# SERVICE BULLETIN

## M1468: 2017 - 2018 Touring and Trike - Clutch Switch Update

M1468

2018-03-12

Figure 1. Machined Dot

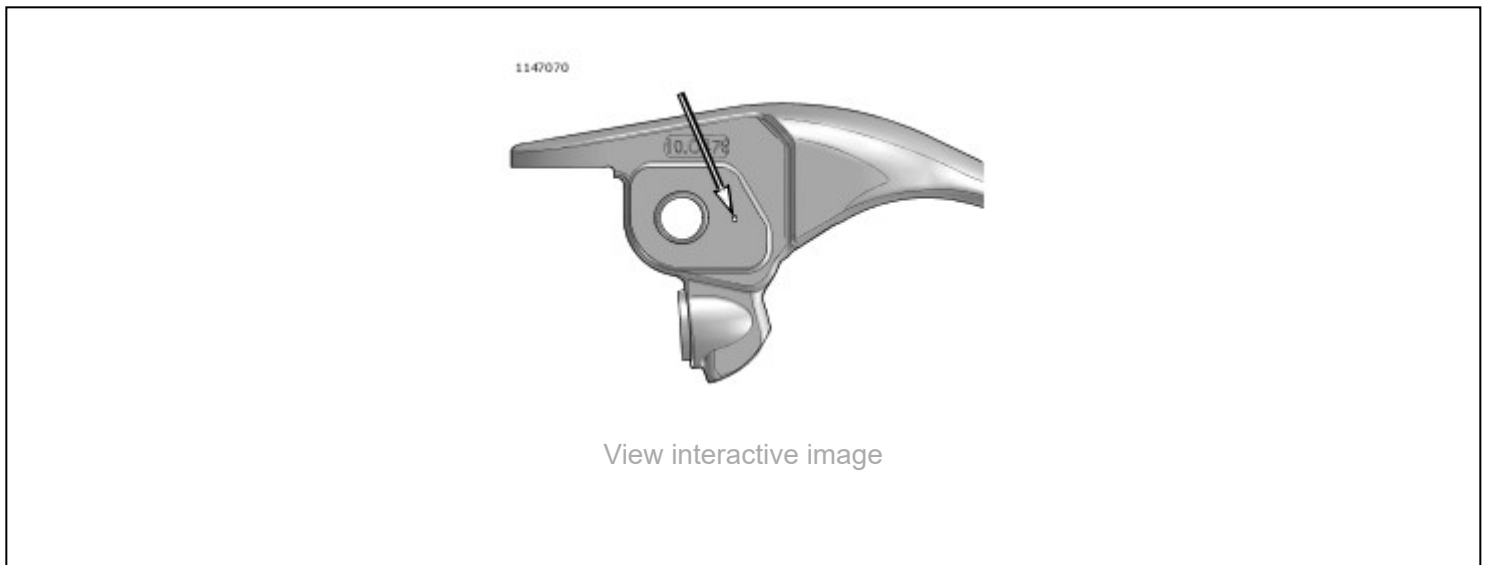
This bulletin informs the dealer network that a revised [LHCM \(Left hand control module\)](#) is available. The **new** parts have a stronger spring in the clutch switch to improve reliability. **New** clutch levers are also available in conjunction with the **new** [LHCM](#). The **new** clutch levers have an improved ramp design that interfaces with the switch. The **new** levers can be identified by a machined dot.

1. Verify vehicle does not start in gear with clutch lever pulled in.
2. If vehicle does not start in gear with clutch lever pulled in.
  - a. Replace [LHCM](#) with updated unit. [Refer to Table 3.](#)
3. [Refer to Figure 1.](#) Inspect clutch lever for machined dot
4. If machined dot is not present, replace clutch lever with updated part. [Refer to Table 5.](#)
